**Subject: Quarterly Groundwater Monitoring
Ash Landfill, Seneca Army Depot Activity
Romulus, New York**

This letter is in response to comments from the U.S. Environmental Protection Agency Region II (USEPA) dated October 10, 2003, regarding the 2003 First Quarterly Monitoring Report for the Ash Landfill at the Seneca Army Depot Activity in Romulus, New York. The comments and subsequent responses are presented below.

Figure L-3
TCE AND DCE Variation With Groundwater Elevation
Groundwater Monitoring - Ash Landfill
Seneca Army Depot

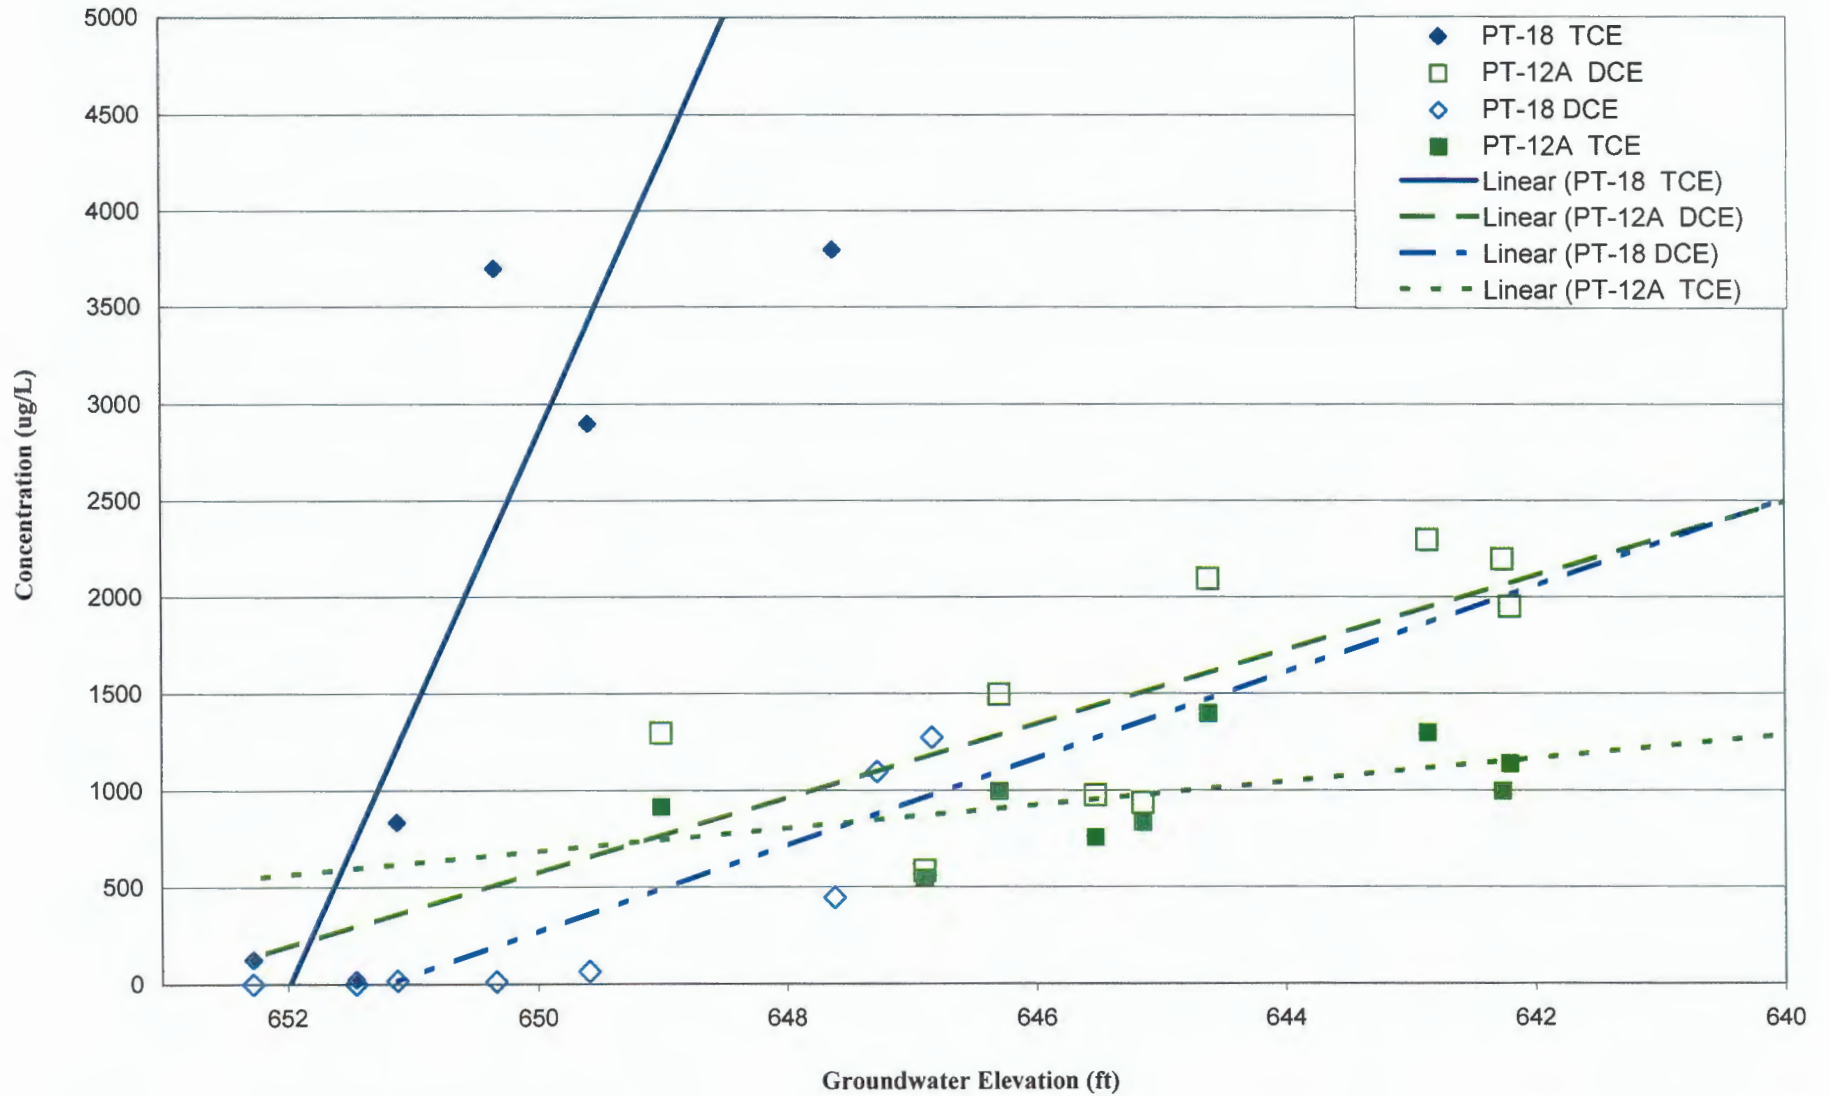
The comparison between October 1999 and March 2003 via figures of the extent of the total voc plume is appreciated, and helps assessment. It is noted that the outer contour in March 2003 is the 1 ug/l detection, while the October 1999 figure was necessarily limited to 10 ug/l. Based on groundwater flow in the upper aquifer, it is reasonable to assume that not all of the plume as delineated will intercept the reactive wall. This was also shown to be occurring in October 1999. The results for MWT-9 are not correctly depicted in the contours. The figures appear to have some generalizations that may not be reflective of actual sampling results. There also appears to be a significant seasonal fluctuation in constituents. Please clarify if use of October results is appropriate for comparison with March results.

We concur there are various seasonal fluctuations in constituents at the site. This is evidenced by plotting contaminant concentration versus groundwater elevation at various monitoring wells around the site. For example, the attached Figure L-3 illustrates an extreme fluctuation of TCE concentration with groundwater elevation at monitoring well PT-18 and moderate fluctuations of DCE with groundwater elevations at PT-12A and PT-18.

**FIGURE 3-7
COMPETENT SHALE
TOPOGRAPHY MAP**

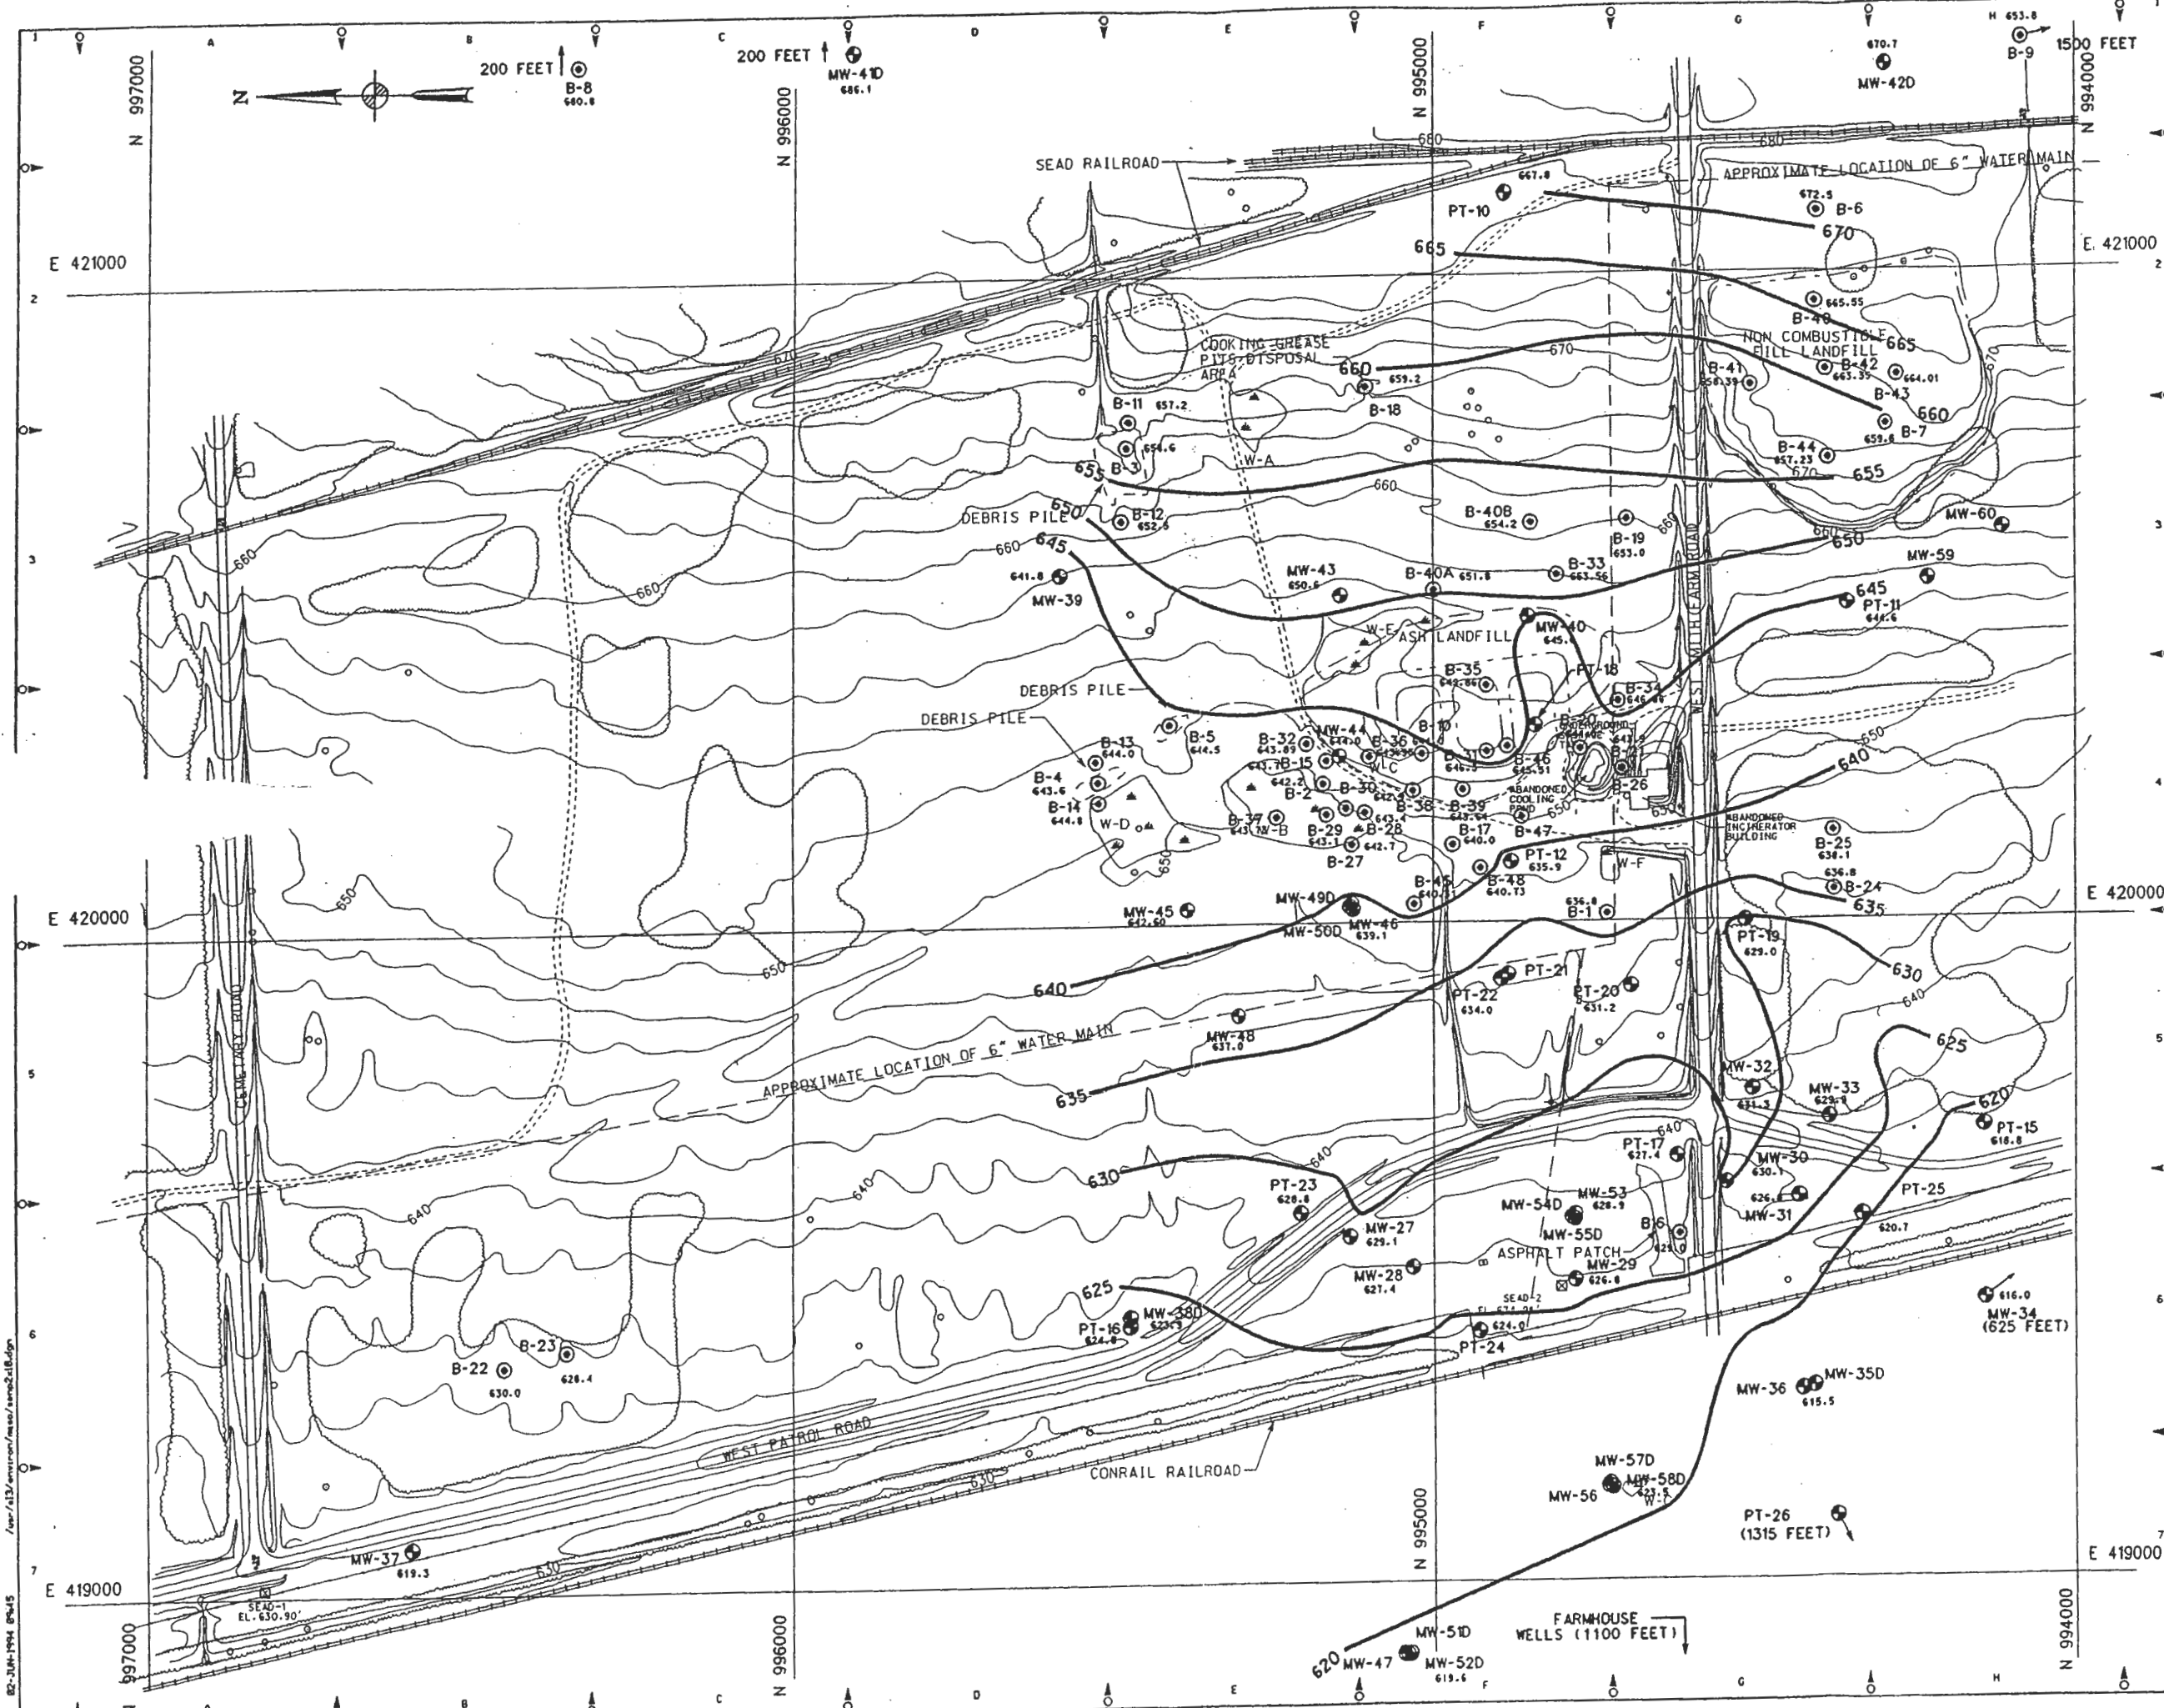
Concurrence with the statement that during low flow conditions, the groundwater may migrate laterally within the wall (page4). This also becomes more evident as the wall becomes fouled or plugged.

Secondary to the east-west trend, groundwater movement trends toward the section of wall between monitoring wells MWT-5 and MWT-8. This secondary trend appears to coincide with a dip in bedrock in this area of the wall. As noted previously, groundwater movement may be affected by bedrock topography. The slight bedrock depression in this area of the wall appears to extend and dip from the slight bedrock trough in the area of monitoring well PT-17, as illustrated in Figure 3-7, Competent Shale Topography Map, of the Remedial Investigation Report at the Ash Landfill (June 1994), a copy of which is attached for reference.
